WILLIAMSON COUNTY, TEXAS

CHANGE ORDER NUMBER: 22

Project Name: FM 3349 at US 79

**FM3349 at US 79
Williamson County Project No. 22IFB139**

TCP-TEMPORARY DETOUR PLAN AND PROFILE TMP-4

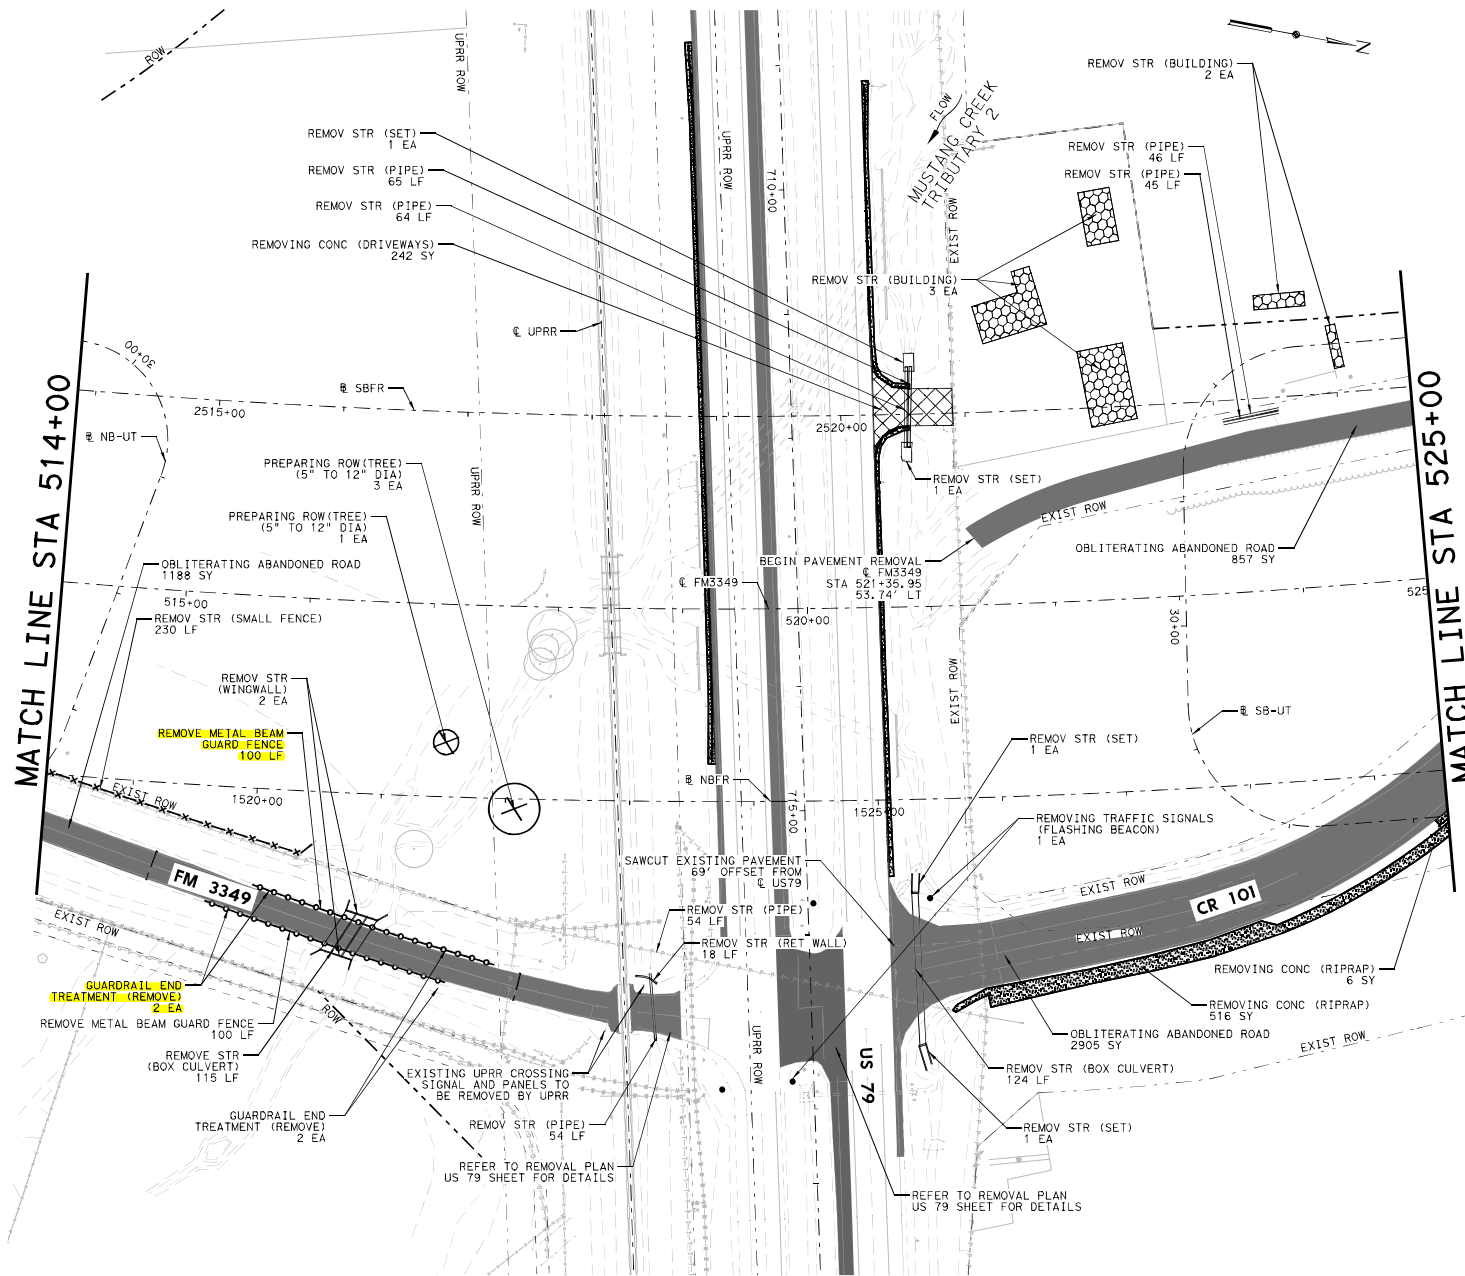
RFI Detail:
JCG has identified a couple of concerns with the temporary detour TMP-4 for diverting SB traffic on to SBFR. Referring to plan sheet 129 there is no barrier to protect the columns for bent 6 or the culvert C-UT-CV-01 located on either side of the detour. The other concern is the MBGF which will need to be moved and reset; however, the plans only call to remove. Please advise JCG on how HNTB would like to proceed and/or means and methods for resolution.

Response:
Attached are markups on Sheet 129 with our recommendation to shield the Bent 6 columns.
Signature: <u>Srikanth Koneru, P.E</u> Date: <u>11/11/2024</u>
